Access Compliance Report

Public Rights-of-Way

(Curb Ramps)

Intersection ID: 16114	Main Street: HAMPTON_AV	Cross Street: OXFORD_PL	Location: SW
ADA ID: 49DAD46403AB	Ramp Type: PerpDiag	Initial Pass/Fail: Fail	Overall Compliance: No
Severity Score: 37.5			
Codes/Mitigation Info/Possible Solution		Field Measurements/Component Compliance

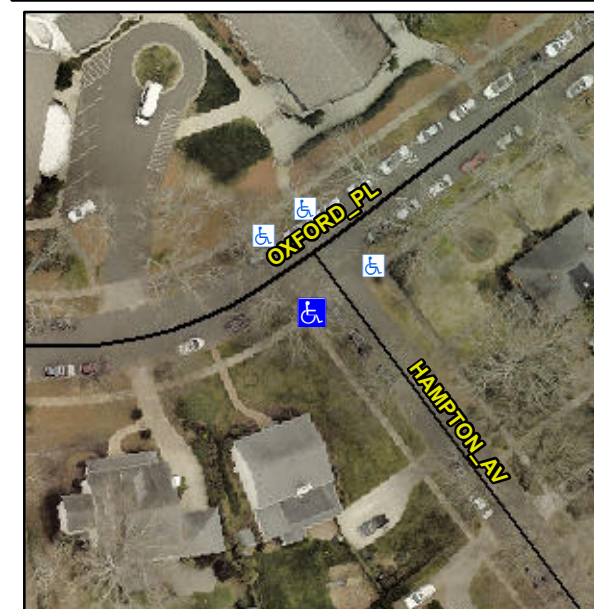
Not Found, R304.2.2, R304.5.3

Compliance	Description	Data	Compliance	Description	Data
N/A	Ramp Length (in)	82.0	No	Ramp Slope (%)	17.1
Yes	Ramp Width (in)	48.0	No	Ramp XSlope (%)	6.0
N/A	Flare Type LT	N/A	N/A	Flare Type RT	N/A
N/A	Flare Slope LT (%)	N/A	N/A	Flare Slope RT (%)	N/A
N/A	Flare Traversable LT?	N/A	N/A	Flare Traversable RT?	N/A
N/A	Landing Length (in)	N/A	N/A	DWS Provided?	N/A
N/A	Landing Width (in)	N/A	N/A	DWS Contrast?	N/A
N/A	Landing Slope (%)	N/A	N/A	DWS Length (in)	N/A
N/A	Landing X Slope (%)	N/A	N/A	DWS Full Width?	N/A
N/A	Landing Curb? (Y/N)	N/A	N/A	DWS Offset (in)	N/A
N/A	Shared Landing?	N/A			
N/A	Gutter Ponding?	N/A	N/A	Gutter Slope (%)	N/A
N/A	Gutter Lip Ht (in)	2.0	N/A	Gutter X Slope (%)	N/A
N/A	Painted X Walk1?	No	N/A	Painted X Walk2?	No
	X Walk 1 Direction	To NE		X Walk 2 Direction	To N
N/A	X Walk 1 Width (in)	N/A	N/A	X Walk 2 Width (in)	N/A
	X Walk 1 Slope (%)	0.2		X Walk 2 Slope (%)	3.4
	X Walk 1 X Slope (%)	2.5		X Walk 2 X Slope (%)	1.4

Remove & Replace Curb Ramp With Two New Directional Ramps or Equivalent.
